January 10, 2019
RS# 2017-014

**SUBJECT: Letter of Opinion – Boundary Tree Setback Encroachment,
233 and 246 Dunlop St. West, City of Barrie**

SITE PLAN 1:250

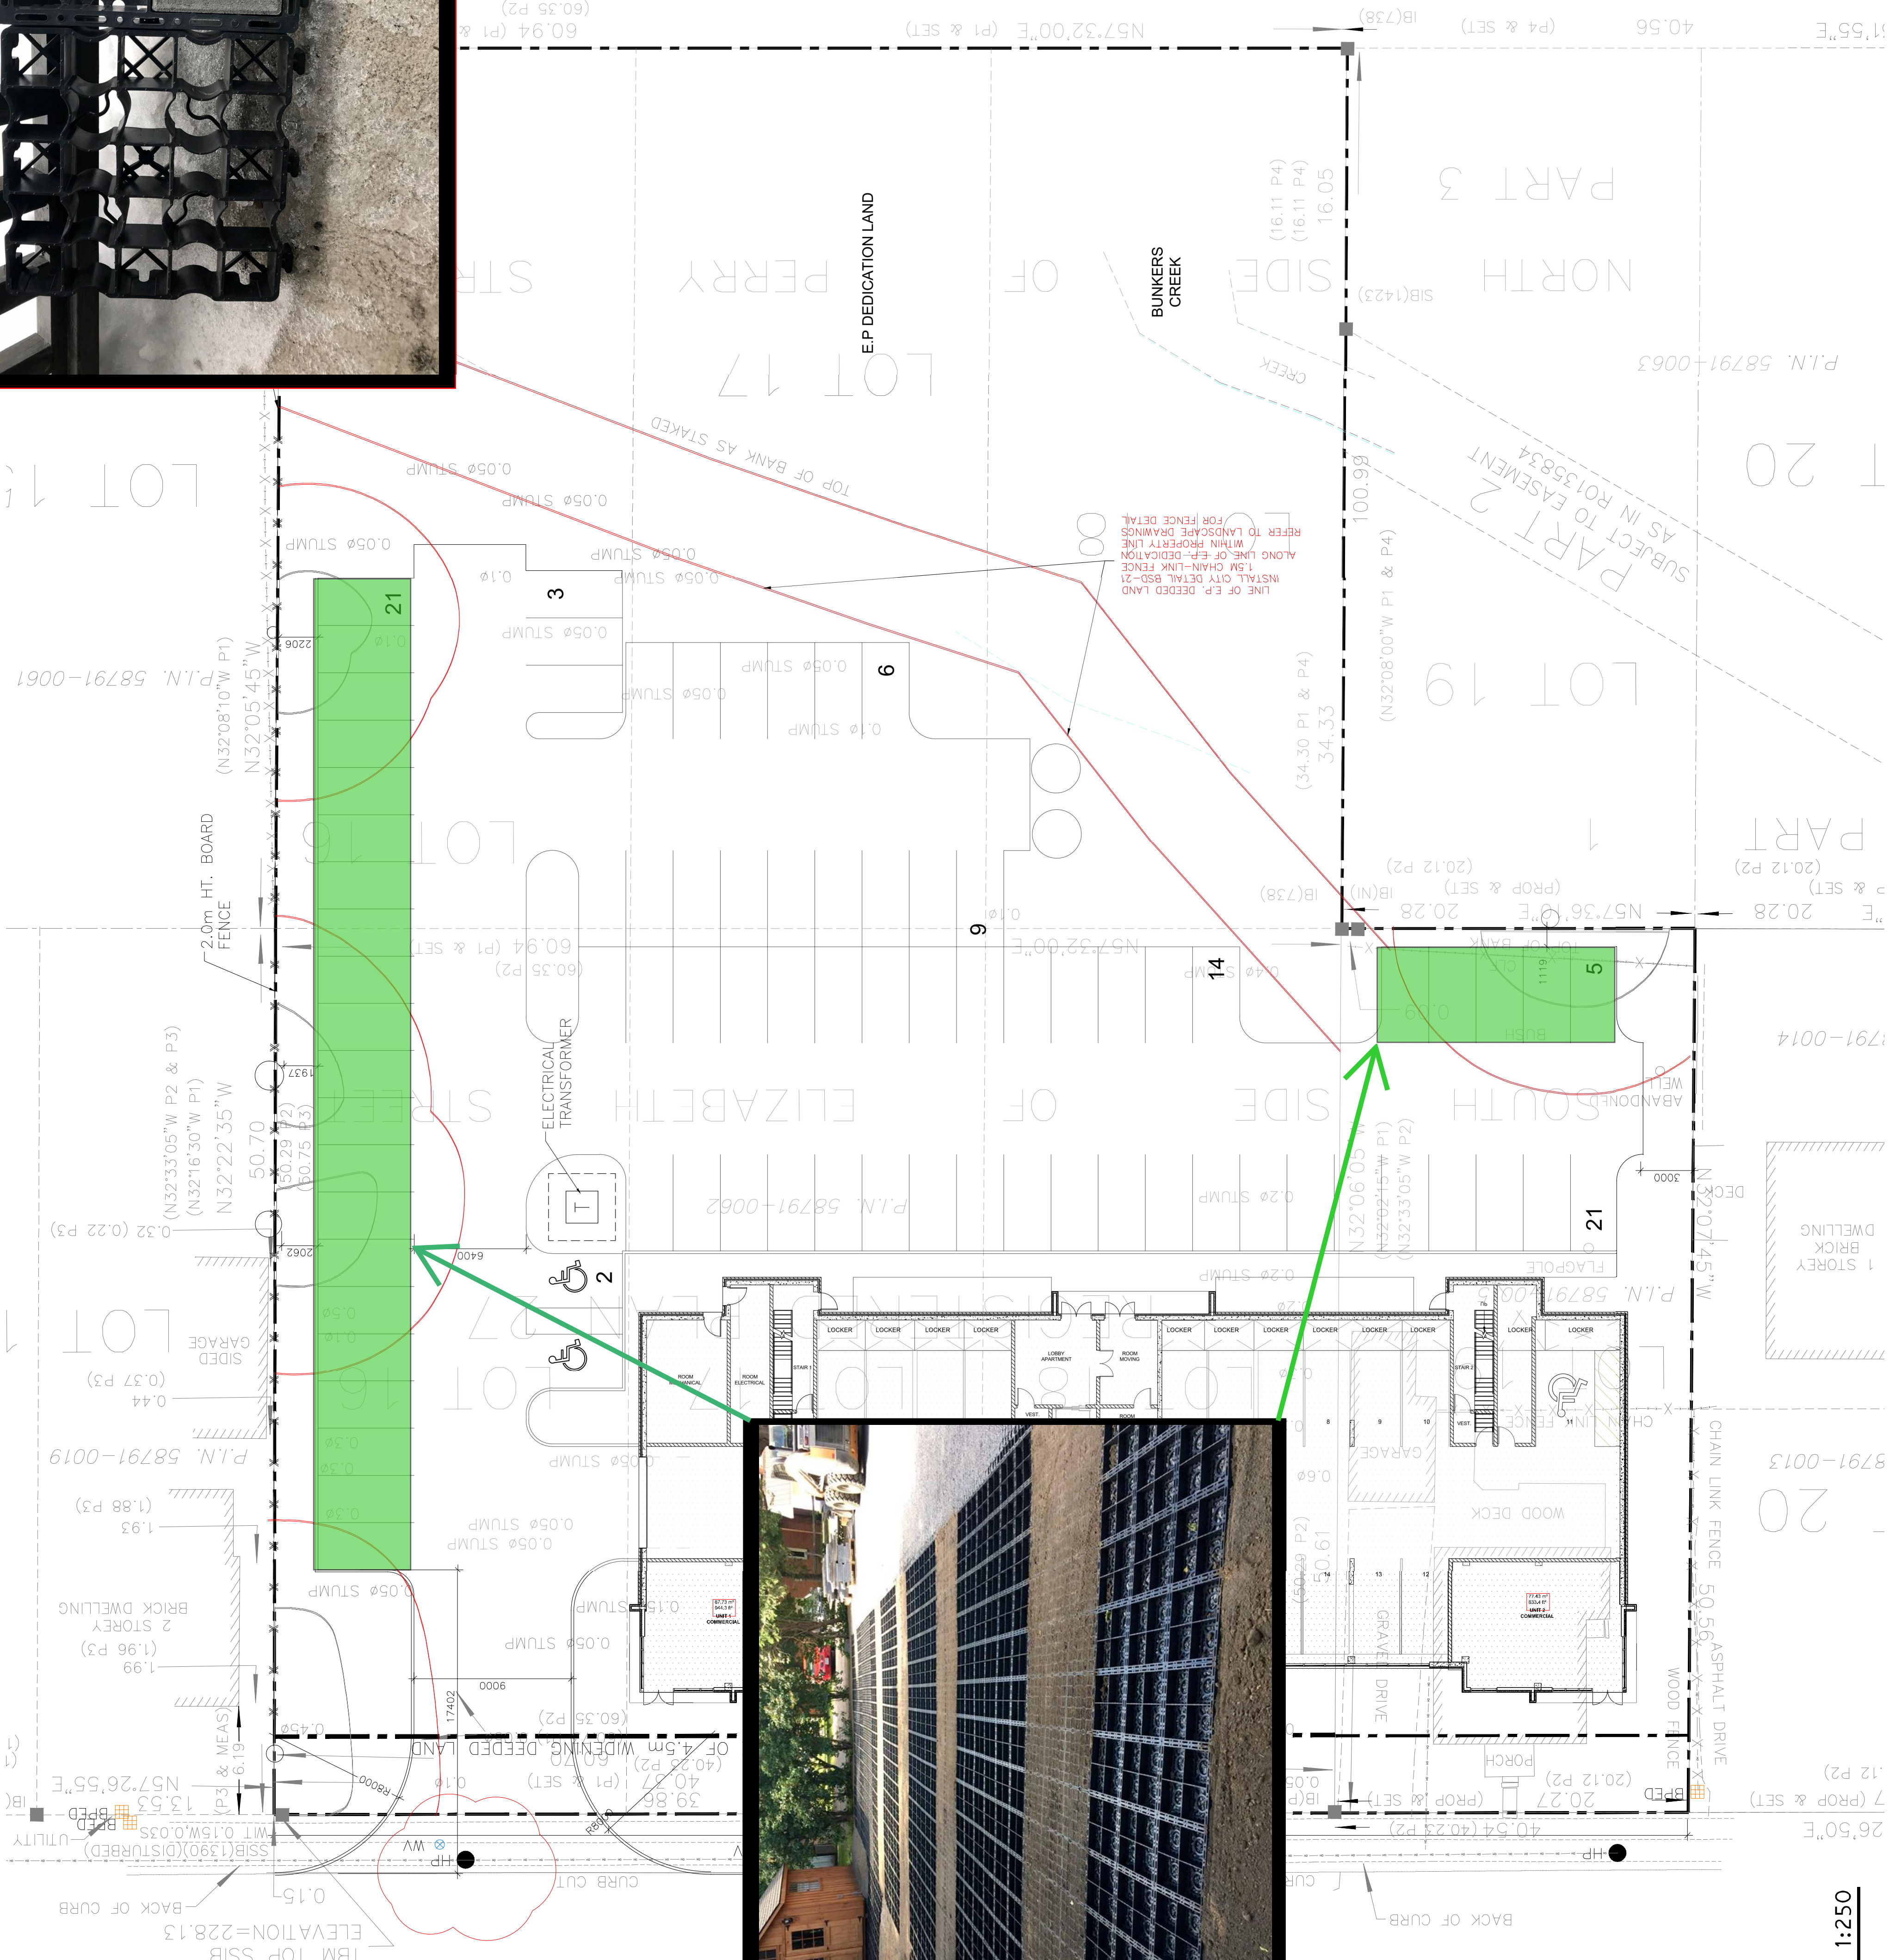
- **During grading and site alteration of the parking areas identified on the Figure below, care should be taken to not grade beyond the necessary depth for the parking base, and hand tools be used where needed to expose tree roots.**

- **In order to encourage infiltration of water into the ground in the area of the boundary trees, permeable materials will be used for the parking surface. The product pictures shown on the attached Figure below is Ecoraster, an interlocking grid product, that is filled with crushed gravel and allows considerable infiltration of water, as opposed to conventional pavement. Ecoraster or similar type product will be used in the parking areas shown on the Figure below.**
